SERIAL: HNP-00-102
10CFR50.90

SHEARON HARRIS NUCLEAR POWER PLANT
DOCKET NO. 50-400/LICENSE NO. NPF-63
SUPPLEMENTAL CHANGES TO
LICENSE AMENDMENT REQUEST -
SPENT FUEL STORAGE

SHEARON HARRIS NUCLEAR POWER PLANT
NRC DOCKET NO. 50-400/LICENSE NO. NPF-63
SUPPLEMENTAL CHANGES TO
LICENSE AMENDMENT REQUEST –
SPENT FUEL STORAGE

TECHNICAL SPECIFICATION PAGES

FIGURE 5.6-1
BURNUP VERSUS ENRICHMENT FOR PWR FUEL

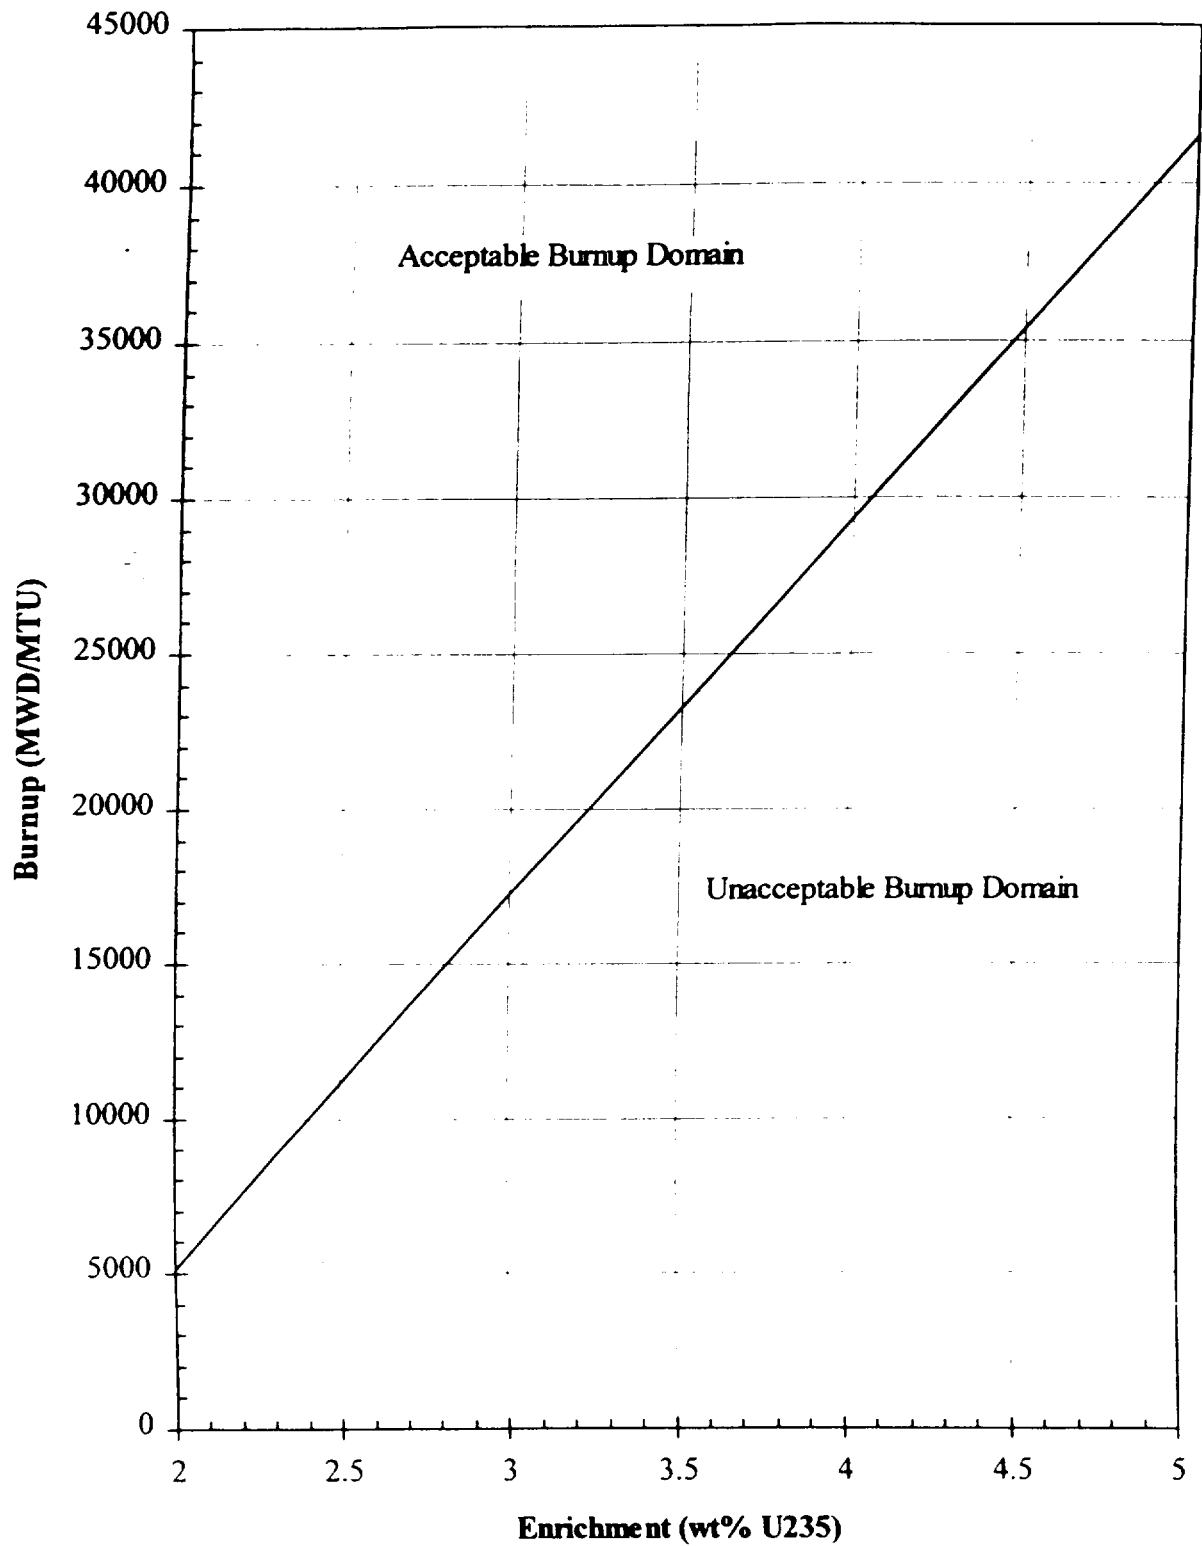
Insert Figure 5.6-1 on new page# 5-7b

- a. PWR assemblies must be within the "acceptable range" of the burnup restrictions shown in Figure 5.6-1 prior to storage in Pools "C" or "D".
 - b. BWR assemblies are acceptable for storage in Pool "C" provided the maximum planar average enrichments are less than 4.6 wt% U235 and K_{inf} is less than or equal to 1.32 for the standard cold core geometry (SCCG).

- a. PWR assemblies must be within the "acceptable range" of the burnup restrictions shown in Figure 5.6-1 prior to storage in Pools "C" or "D".
 - b. BWR assemblies are acceptable for storage in Pool "C" provided the maximum planar average enrichments are less than 4.6 wt% U235 and K_{inf} is less than or equal to 1.32 for the standard cold core geometry (SCCG).
